# D/DRC Case

823 Lady Street  
City Center Design/Development District  
TMS: 09013-13-17

**DESIGN/DEVELOPMENT REVIEW COMMISSION**  
**DESIGN REVIEW DISTRICT**  
**EVALUATION SHEET**  
Case #1

**NATURE OF REQUEST:** Request for Certificate of Design Approval for new construction of Aloft hotel.

ALOFT HOTEL  
PRELIMINARY LANDSCAPE PLAN & PLANT SCHEDULE

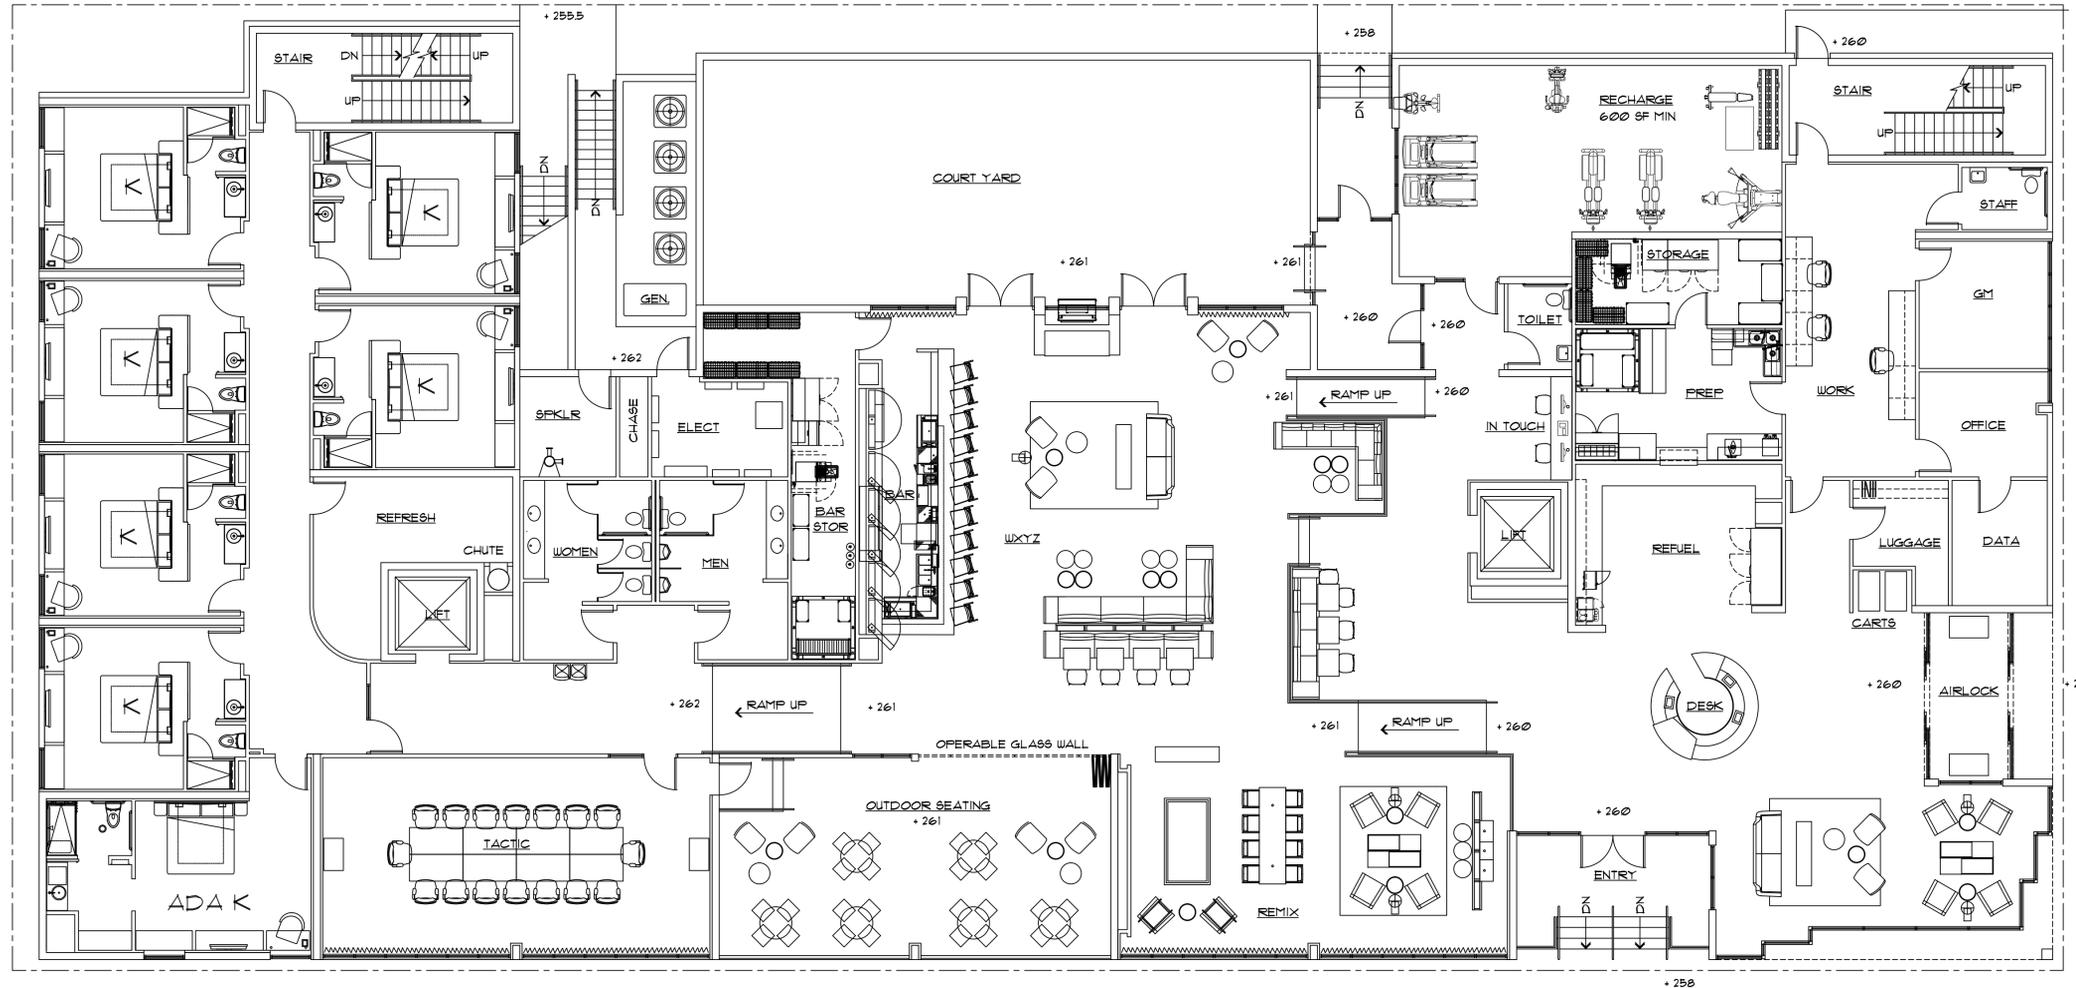
The east portion of the parcel is being transformed from a driveway to an outdoor patio and pedestrian alley that leads to the parking garage on the adjacent parcel. The design of this alley is critical to provide a safe, attractive, highly finished urban space for pedestrians to use, as this will likely be the primary route from the parking garage to the Vista. The applicant has retained a landscape architect to design the space.

Staff recommends that more shade be incorporated. Since there are underground utilities, the recommendation is to provide an arbor structure or green screen to provide at least shade along the western edge of the walkway and patio, if not along the southern edge of the patio as well.

Staff also recommends that lighting to match the Vista streetscape lighting be provided for safety and continuity as a public access-way.

- The vertical panels be extended to the accent band above the fifth floor, and continued in the same pattern on the western façade.
- Planters or a mural be added to the Lady Street façade beneath the outdoor dining area to provide interest to a blank brick wall.
- An arbor or green-screen be added to the patio/alleyway to provide shade and to soften the hardscape
- Lighting to match the Lady Street streetscape be added to the pedestrian walkway to the garage.

Drawing Title  
 EXTERIOR ELEVATIONS

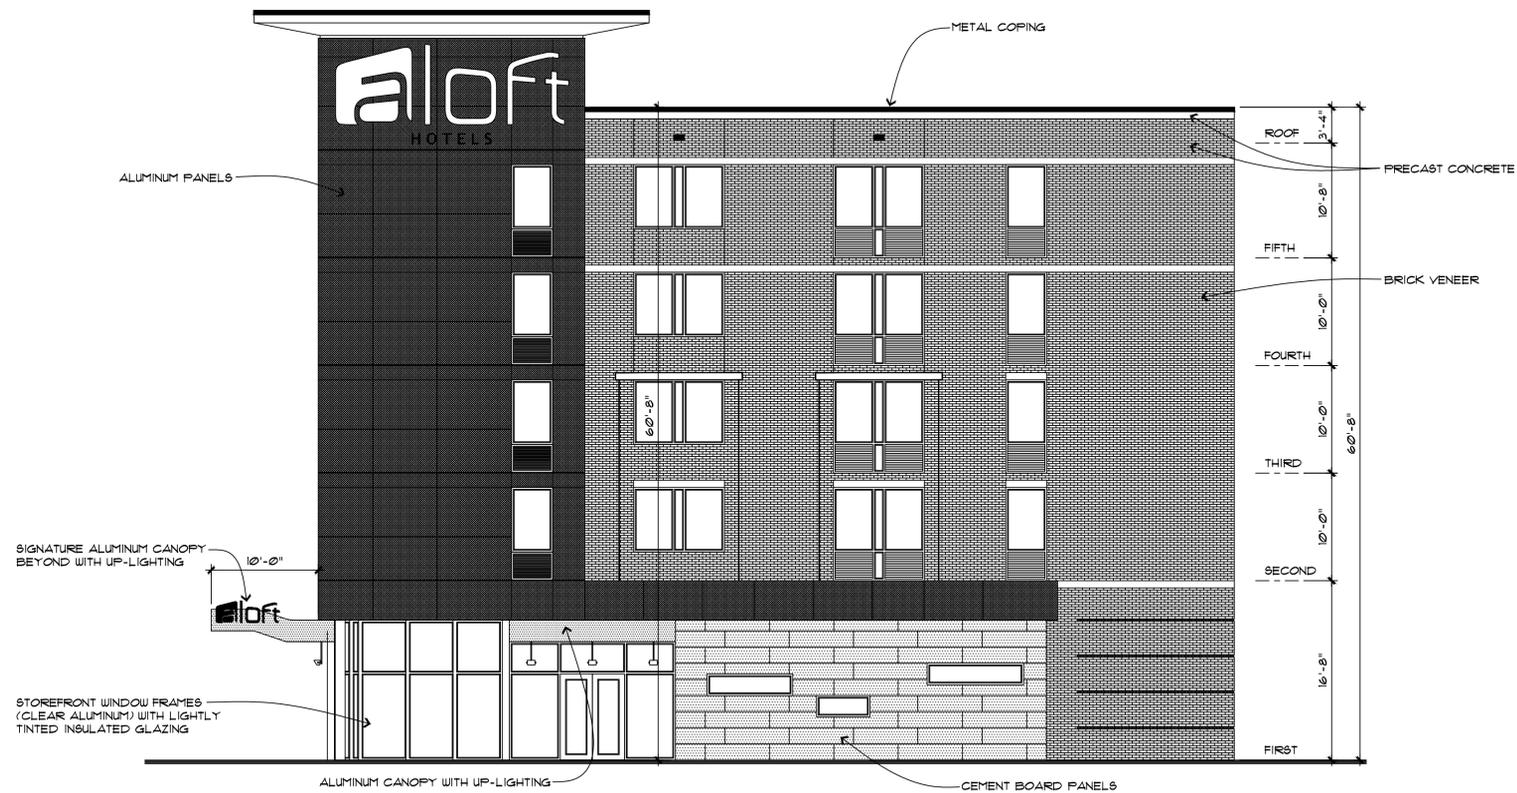
The Commission had some concerns about the massing during the informational presentation last week. To address this, the architect has removed the horizontal cast stone accent band from between the 1<sup>st</sup> and 2<sup>nd</sup> floors and also from between the 2<sup>nd</sup> and 3<sup>rd</sup> floors. He has added extruded, darker brick accent panels around the second and third floor windows to add vertical articulation, both to the east and south facades. The termination of the darker panel above the third floor seems abrupt and random. Staff recommends that this detail continue up to the cast stone band on above the 5<sup>th</sup> floor windows, and also be added to the west façade for a consistent design concept that relates to the corner tower.

The percentage of storefront at the street level is very high at the corner and along the lobby. The architect has added some accents to the blank portion of wall on Lincoln Street to address concerns about the blank wall.

Along Lady Street, the storefront is continuous until the grade starts to drop in front of the basement. While windows do not make sense here, this expanse of wall below the outdoor dining area needs something to maintain the interest of the pedestrian along this sidewalk. Windows were added along the western end of the Lady Street elevation at the restaurant at the request of staff, which helps with the overall percentage of window openings. Staff recommends some long, rectangular planters below the outdoor dining terrace to soften and add interest to this long, blank expanse of wall.

Lincoln would be considered the side street; there is close to 50% storefront. The suggestion to add a window here was not feasible due to fire-rated stair-well. Brick accents and a small amount of landscaping have been added to this blank section of wall.

The Lady Street entrance is recessed more than the recommended 5 feet. However, it is a few feet above street level. As well, given the use of the building, hotels have an active presence 24/7 that would add a safety element to this space.

The awning on the southwest corner has been added since the informational presentation. It emphasizes the restaurant entrance, and uses the material of the corner tower element, tying it into the overall building design. The awning picks up at a lower level where the dark horizontal band stops along Lady Street, emphasizing the step-down of the façade along the street.

This building has three primary materials, and an accent material. The bulk of the building is brick, which is considered appropriate and widely used. The architect has introduced a second color of brick on the vertical panels surrounding the window pairs on the upper floors. Staff has recommended this concept be explored with the same color brick. The revised plans include a continuous base of cast stone along Lady Street and also on the west elevation, which

Drawing Title  
 EXTERIOR ELEVATIONS

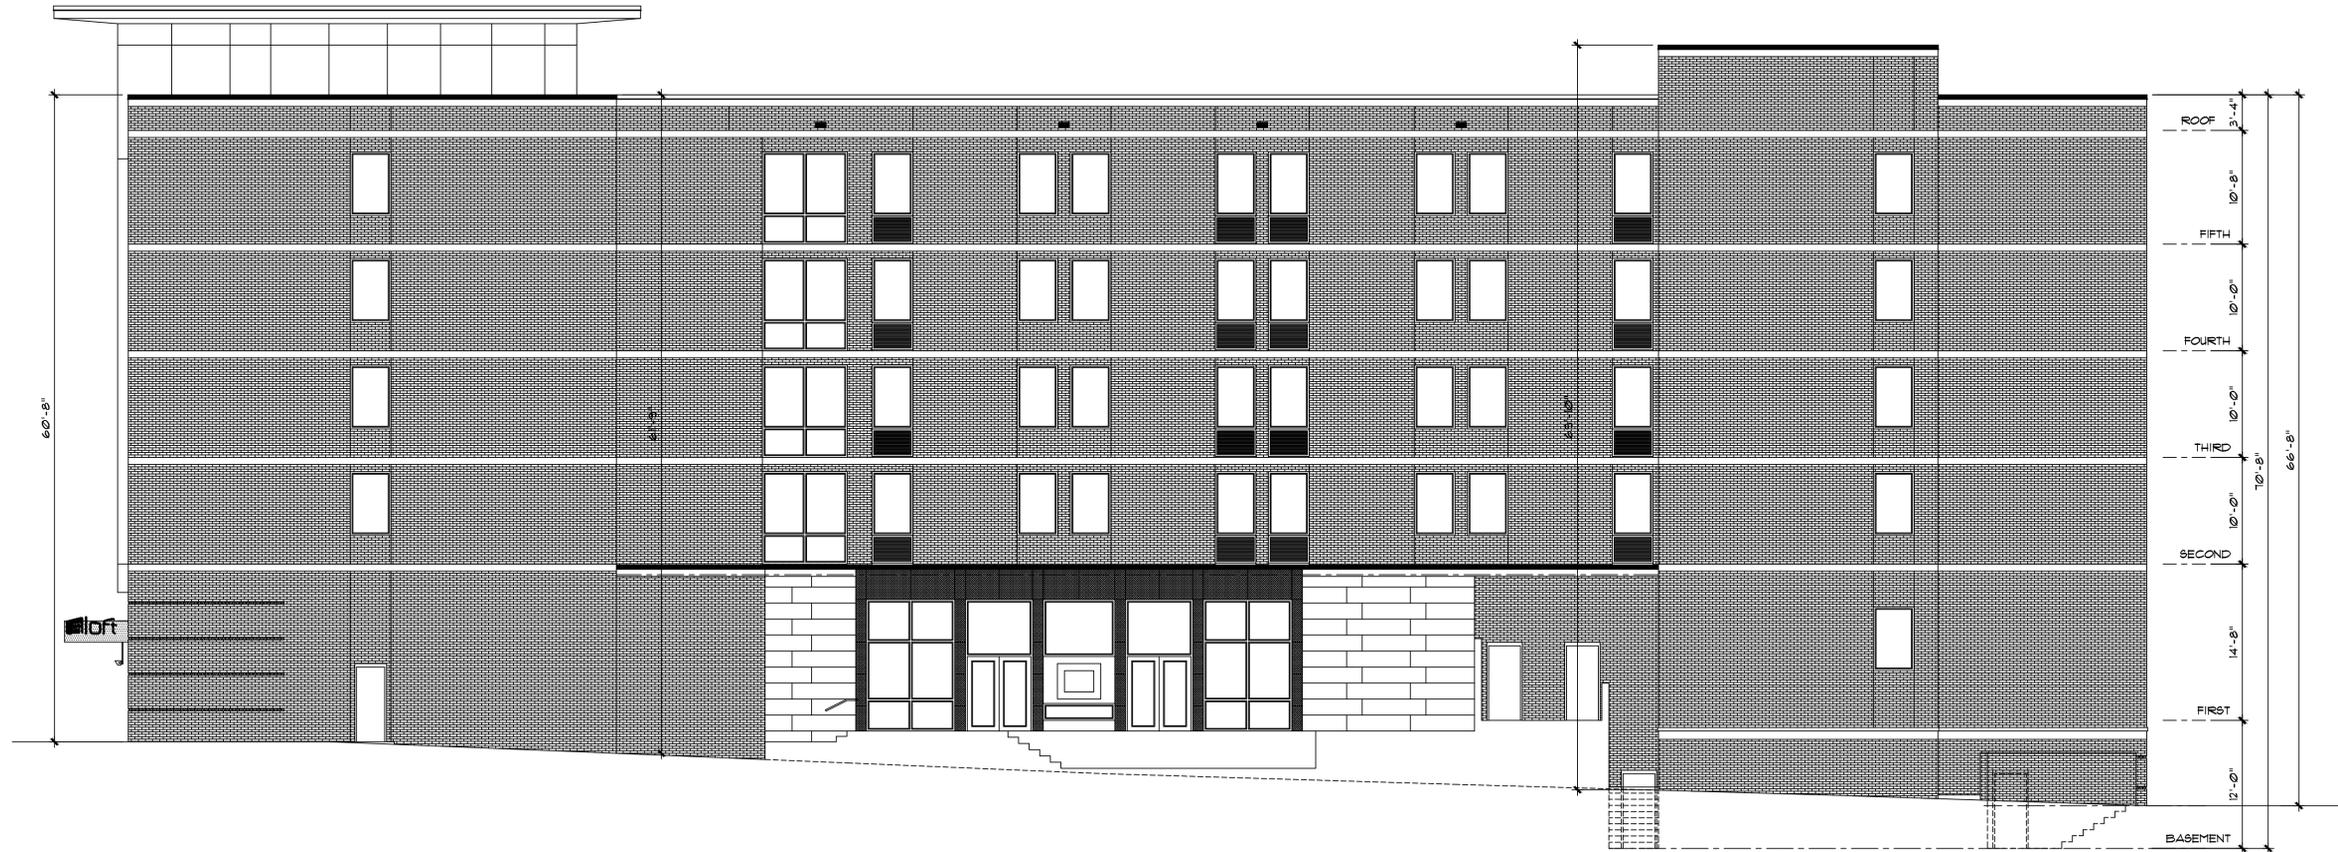
The cement board panels are used as an accent on Lincoln Street and on the rear elevation. The cast concrete detailing is a recommended material and works well as an accent in the large expanse of brick, tying in the base color through the upper façade and again emphasizing the strong horizontal lines of the design.
